II. ANALYSIS METHOD

T.W. ✓ A. Seismic Analysis

page 4-4 / volume I
Hosgrri seismic
evaluation
Amendment
50

MATHEMATICAL MODELS FOR HORIZONTAL,
TORSIONAL, AND VERTICAL ANALYSIS

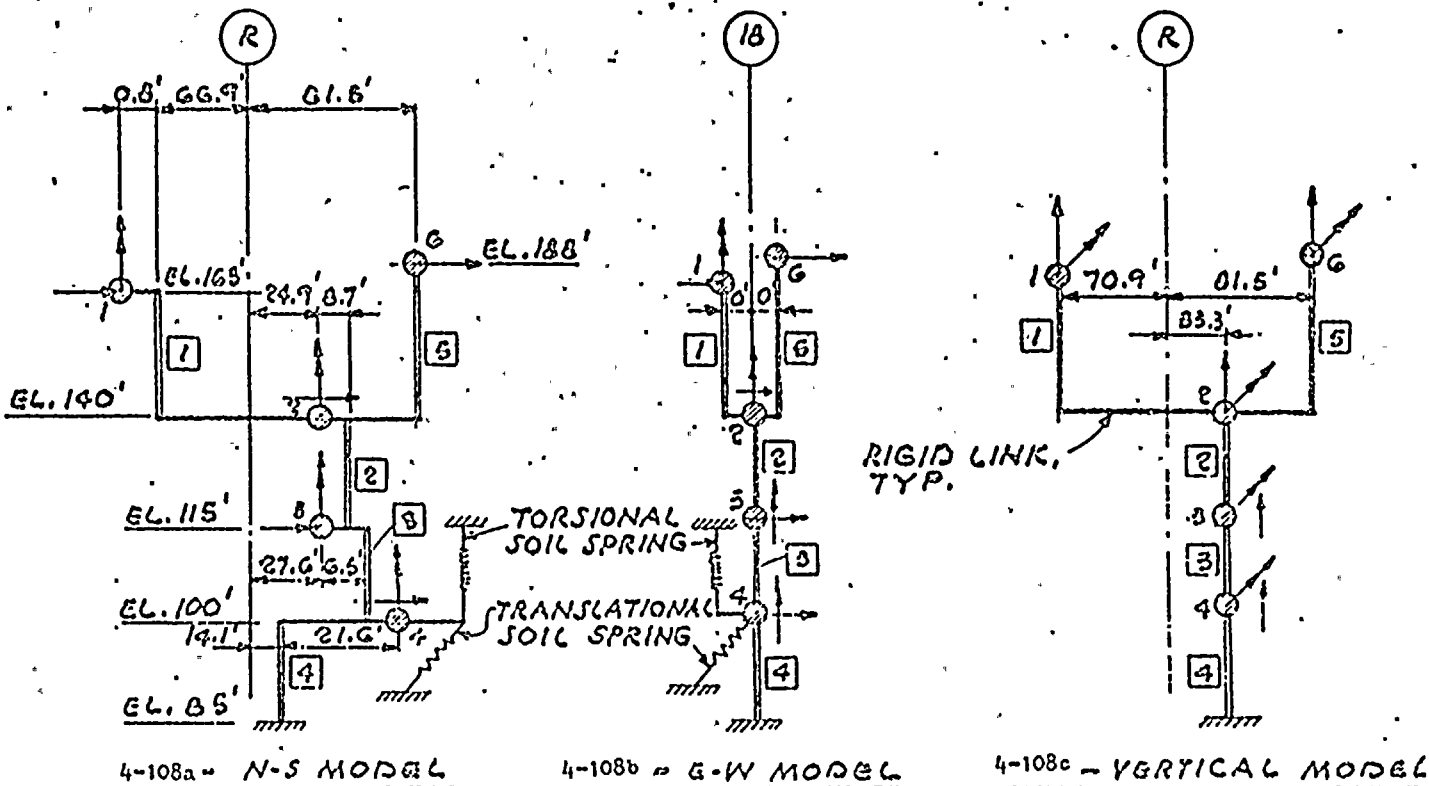
1. Mathematical model-general description with sketch.
Fig 4-108 in Amendment 50
or See next page
